Work Order ID 131608

Item Name: RH Half

ENGINEERING CHANGE NOTICE NO.

DWG TITLE: UPPER CUTTER ASSY

SHEET 4, ZONE B8 IS:

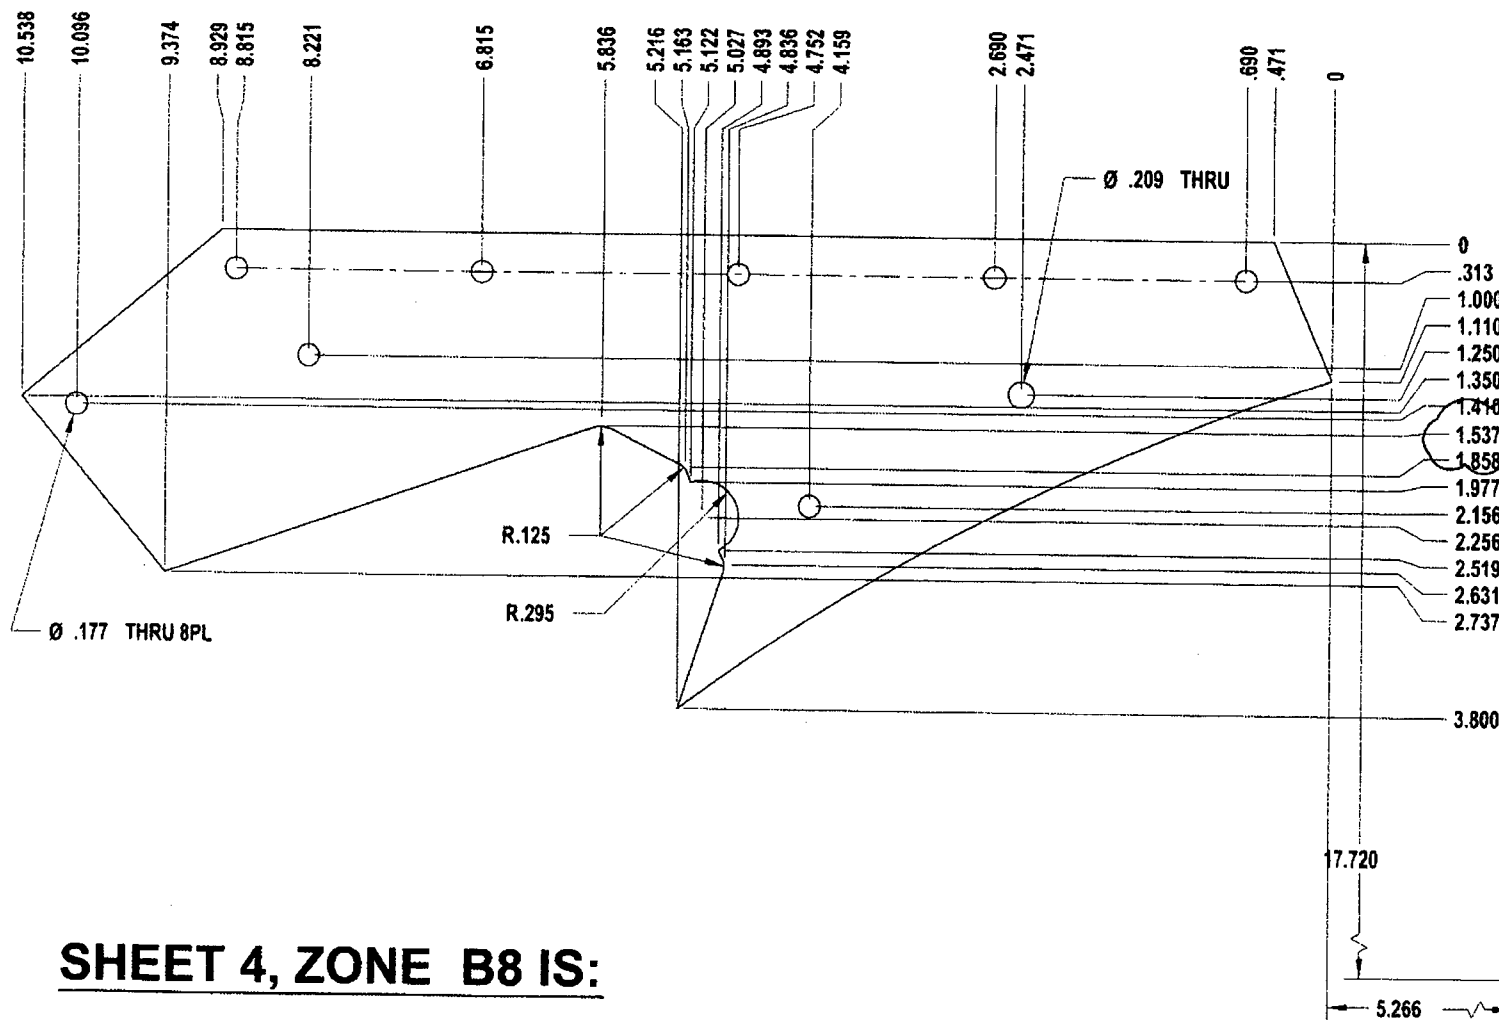
REASON:

REVISED ORDINATE DIMENSION.

SHEET 1, VIEW 646.3301, IS:

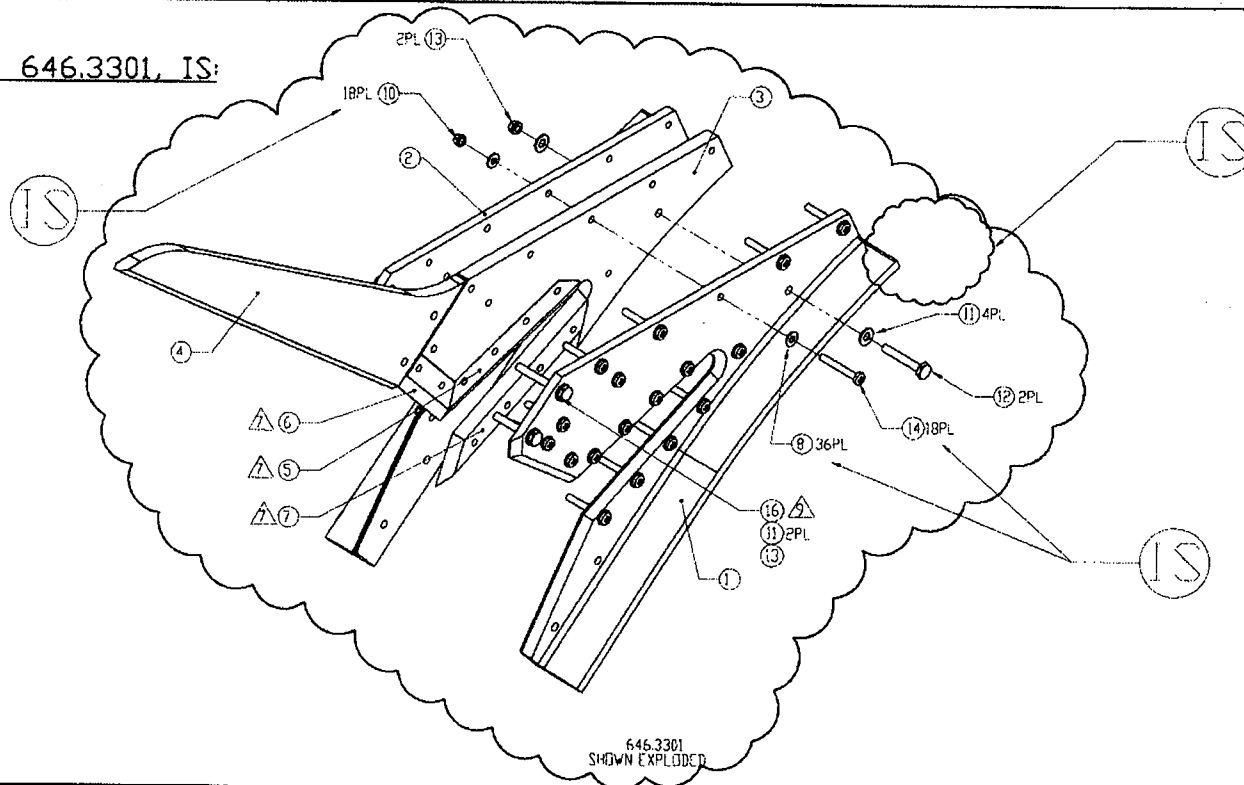
APICAL INDUSTRIES, INC.	ENGINEERING CHANGE NOTICE NO. 02196		SHEET 1 OF 2	
	DWG NO. 646.3300	REV: N/C	PREPARED BY S. HUFF	DATE: 01/05/09
	EFFECT ON DWG ☐ INC. ☒ UNINC.			
	DWG TITLE: UPPER CUTTER ASSY			
APPROVED BY: ENGR <i>[Signature]</i>		MFG <i>[Signature]</i>	QC <i>[Signature]</i>	EFF: NEXT ORDER
TRANSACTION CODES (TC): A-ADD C-CREATE R-REVISE D-DELETE		REASON: REMOVED RIVETS IN FAVOR OF ADDITIONAL SCREWS

14	R	601.2765	18	SCREW	MS27039-0819
10	R	601.1541	18	LOCKNUT	MS21042L08
9	D	601.2766	3	RIVET	MS20470AD5-18
8	R	601.2764	36	WASHER	NAS1149FN832P
			3301		
F/N	TC	PART NUMBER	QTY	DESCRIPTION	MATERIAL/SPECIFICATION
DOCUMENTS EFFECTED:				CHANGE CATEGORY	DER REVIEW REQUIRED
				☐ MDL ☒ INSTALL INSTRUC ☒ ICA ☐ FMS ☒ BOM	☐ MAJOR ☒ MINOR
					☐ YES ☒ NO
